Three Mile Island Nuclear Station, Unit 2 (TMI-2)
Operating License No. DPR-73
Docket No. 50-320
EPICOR II Resin Solidification Procurement Specifications

RE: Solidification of 25 EPICOR Liners,
Inquiry No. 85099, Addendum No. 1

Questions From Bidder's Conference

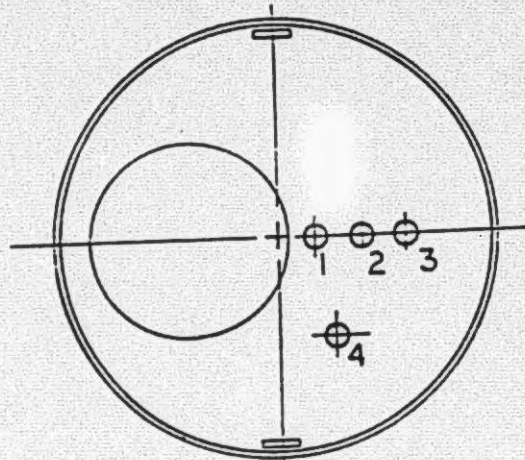
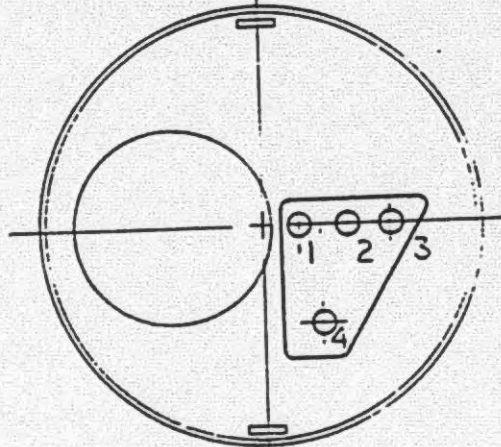
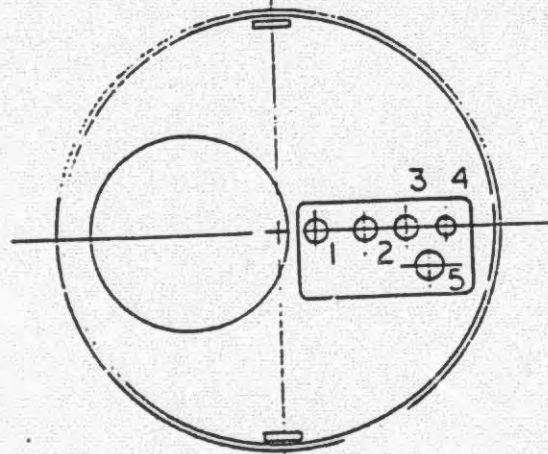
33. Will GPU make available full-scale drawings referenced in the proposal package?

Two liners drawings (JS070880 and BLG2579) are attached regarding Question 1. The details of the liner physical piping arrangements are not available for distribution, however, attachment #1 provides a general presentation of this arrangement.
